World Forum for Harmonization of Vehicle Regulations**Working Party on Lighting and Light-Signalling****Eighty-third session**

Simplification of lighting and light-signalling UN Regulations:**UN Regulation No. 149 (Road illumination devices)****Revised proposal to correct and improve the text of UN
Regulation No. 149****Submitted by the Informal Working Group on Simplification of
Lighting and Light-Signalling Regulations***

Figure A13-III
Marking example 3

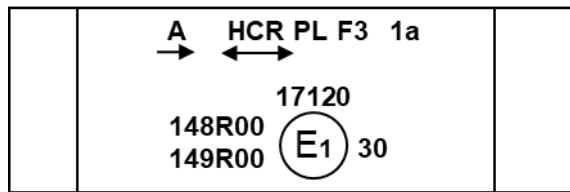
Note: The examples in Figures A13-III and A13-IV correspond to a lighting device bearing an approval mark comprising:

Figure A13-IV
Marking example 4-a

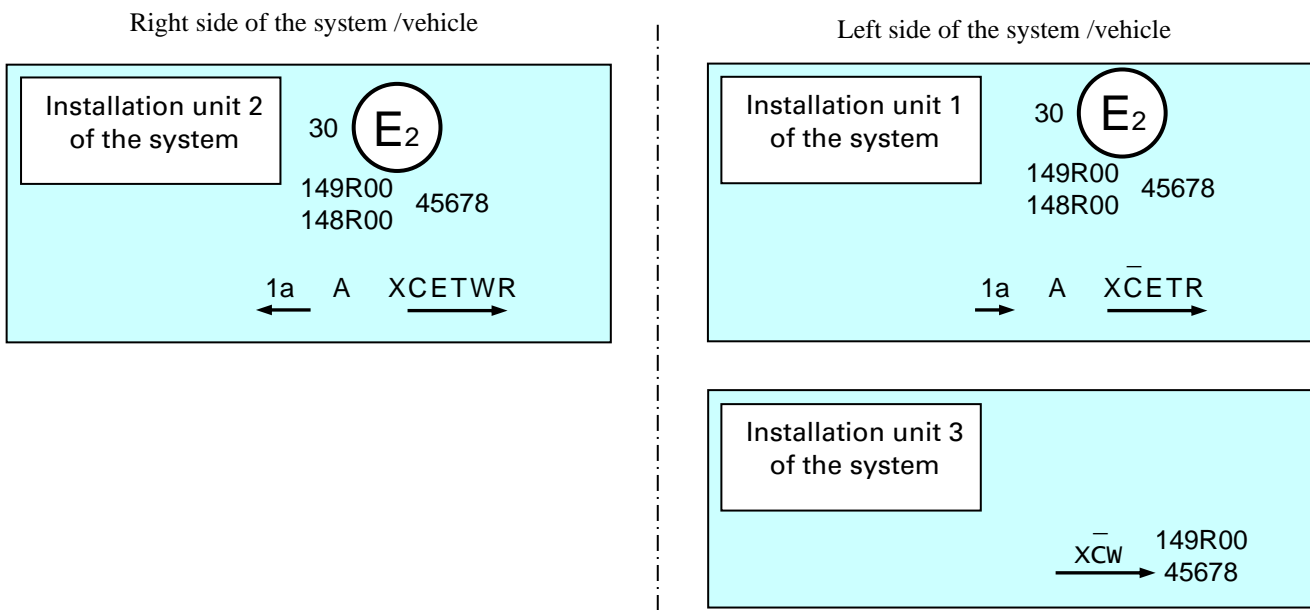
- (a) A front position lamp approved in accordance with the 00 series of amendments to UN Regulation No. 148. The horizontal arrow indicates the side on which the required photometric specifications are met up to an angle of 80° H;
- (b) A headlamp, Class B, with a passing-beam designed for right-hand traffic only and a driving-beam with a maximum intensity comprised between 123,625 and 145,125 candelas (as indicated by the number 30), approved in accordance with the requirements of this Regulation, as amended by the 00 series of amendments and incorporating a lens of plastic material;
- (c) A front fog lamp approved in accordance with the 00 series of amendments of this Regulation and incorporating a lens of plastic material;
- (d) A front direction indicator lamp of category 1a approved in accordance with the 00 series of amendments to UN Regulation No. 148.
